From: Kristopher Steege-Reimann <reimannk@gmail.com>  
Sent: Tuesday, August 25, 2020 8:33 AM  
To: Planning <planning@cityofmadison.com>  
Subject: 817-821 Williamson St

**Project Name & Address:** 817-821 Williamson Street

**Application Type(s):** Certificates of Appropriateness for demolition, new construction, and a land combination in the Third Lake Ridge historic district

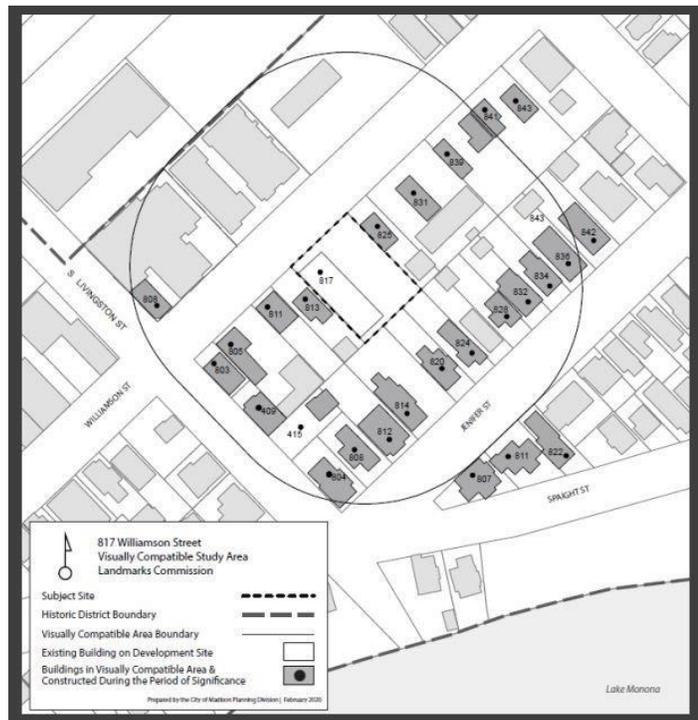
We who live in and near the west end of the Marquette Neighborhood are faced with the prospect of a proposed development for 817 Williamson that is grossly out of scale among the older houses in which we live.

The proposed building for 817 Williamson exceeds the recommended neighborhood plan, BUILD 2, that was adopted by the Madison Plan Commission. It also exceeds the recommended volume of the existing historic buildings within 200 feet of it -- by approximately 8 times. My house was among them.

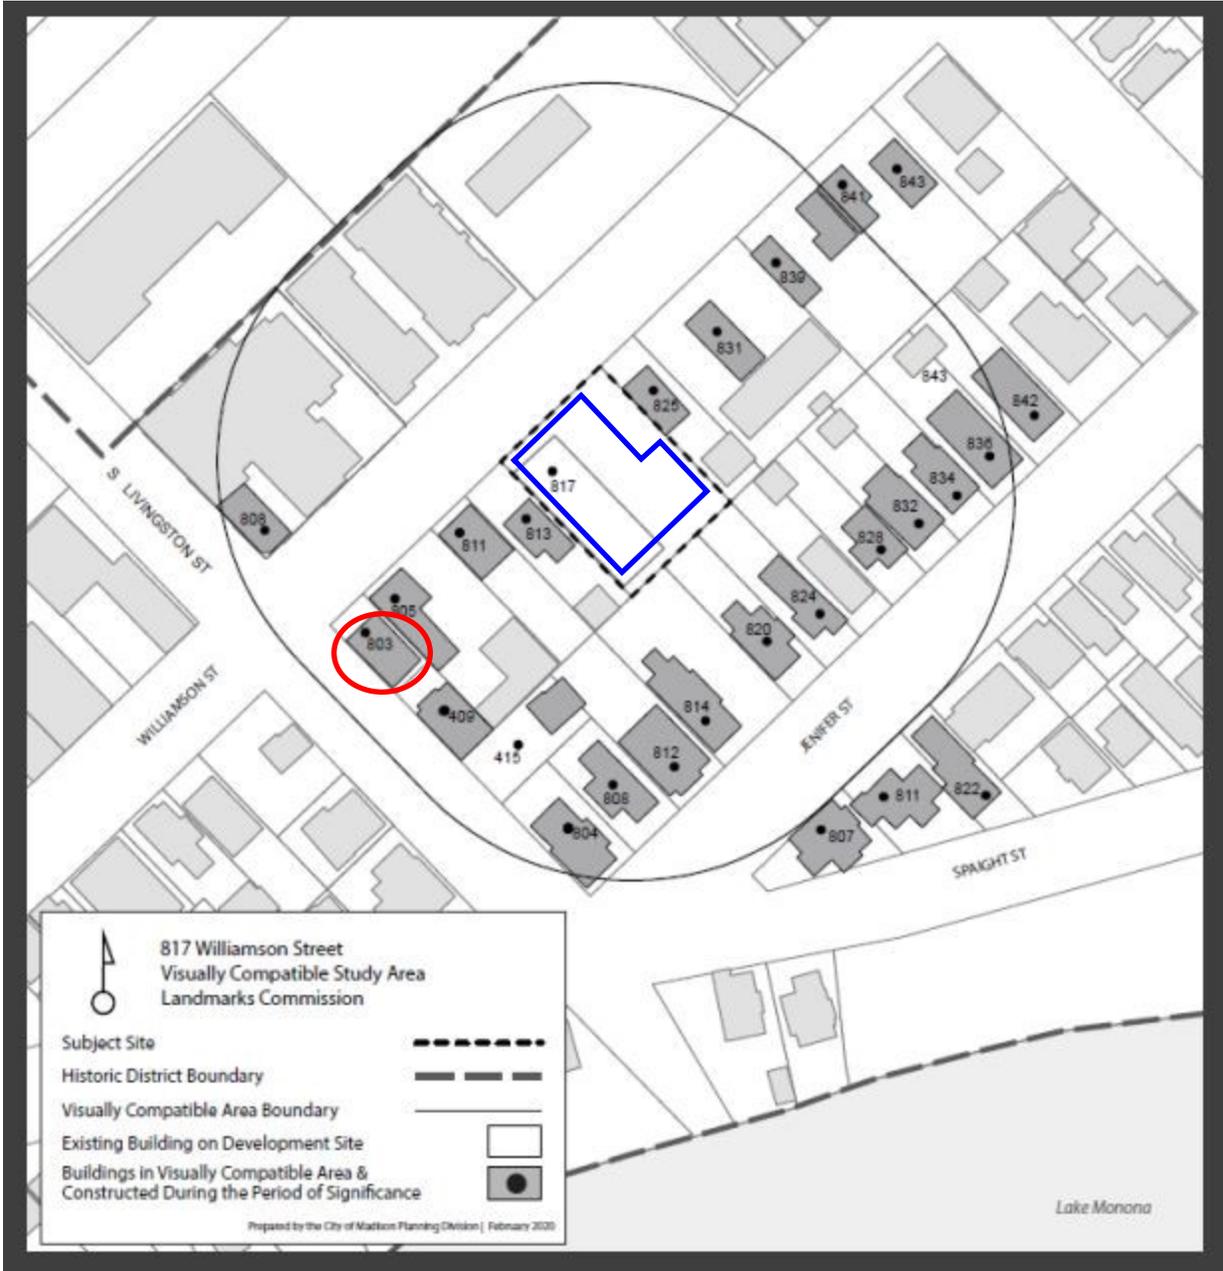
The proposal for 817 Williamson St. does not comply with our Comprehensive Plan or with BUILDII, but those have been better addressed by others. 817 Williamson St. simply put is vastly out of scale with the neighborhood and sets a serious potential for the demise of the entire third Lake Ridge historic district.

The proposal was recently approved by Landmarks Commission without serious discussion of the six standards and with major help from an incorrect and misleading submission from staff. Standards for Third Lake Ridge require compatibility with buildings built before 1929 within 200 feet (VRA) of the subject proposal. The staff drawing of the buildings within 200 feet (Exhibit A) included 803 Williamson St., a lot-filling building built in 2019. Staff then went on to show a photo of 803 as an illustration of why the proposal was compatible. (Exhibit B) Ordinance clearly states that the comparison should be made with “contributing” buildings, in this case buildings built before 1929. 803 Williamson was not built before 1929 and its inclusion here is critically misleading, especially supporting visual compatibility.

Never once in the most recent Landmarks hearing was 41.23 (6) (f), the most relevant standard, discussed. That is the standard that requires compatibility of “the rhythm of building masses and spaces.” The interpretation of this standard has typically been the relationship of the volume of the building to the space around it.
